Technical change to RS IO Interfaces

PCN-number: 20220912

Representative RS IO Interface (w/ LPK SI and LPK3)

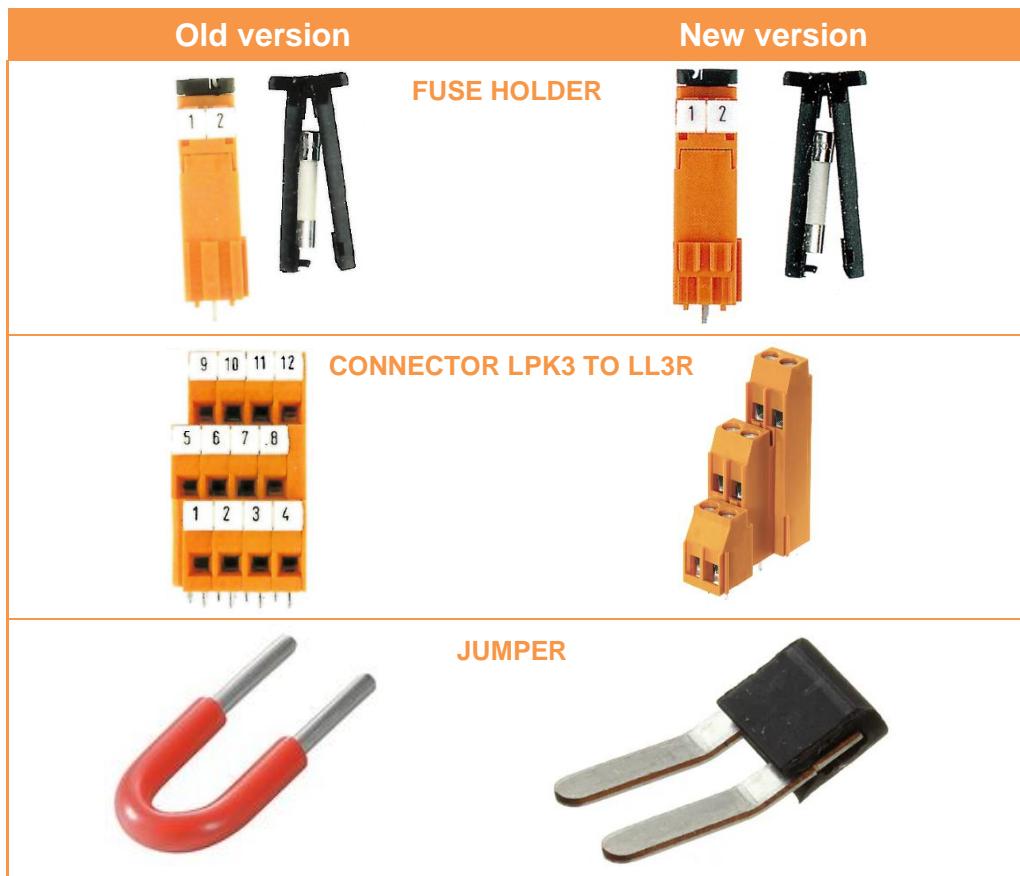
Based on continuous improvement the LPK3 connectors will be replaced by LL3R connectors with Tampoprint. In addition, LPK SI fuse holders will be replaced by LPA SI fuse holders and 1302800000 Jumpers will be replaced by 1472200000 Jumper.

Obsolescence of LPK SI fuse holder, obsolescence of LPK3 connectors and blocking of 1302800000 Jumper.
